PLANNING COMMITTEE 5 June 2017

SUMMARY OF ADDITIONAL CORRESPONDENCE RECEIVED SINCE THE PUBLICATION OF THE AGENDA AND ERRATA

16/02081/F

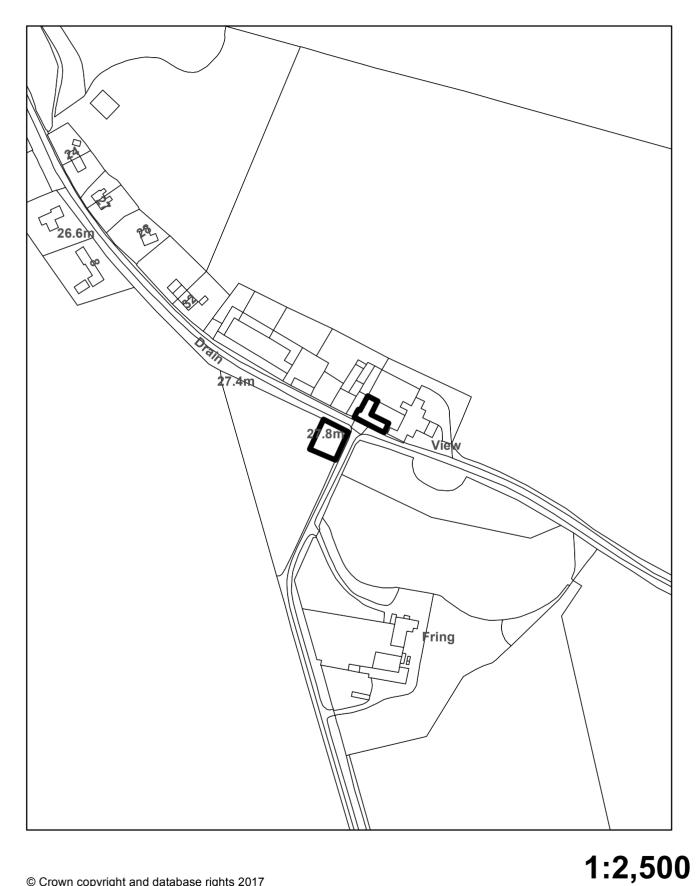
CORRECTION: The application site shown on the location plan at p44 of the Agenda is incorrect.

The correct application site (red line area) is as shown on the location plan attached to this report.
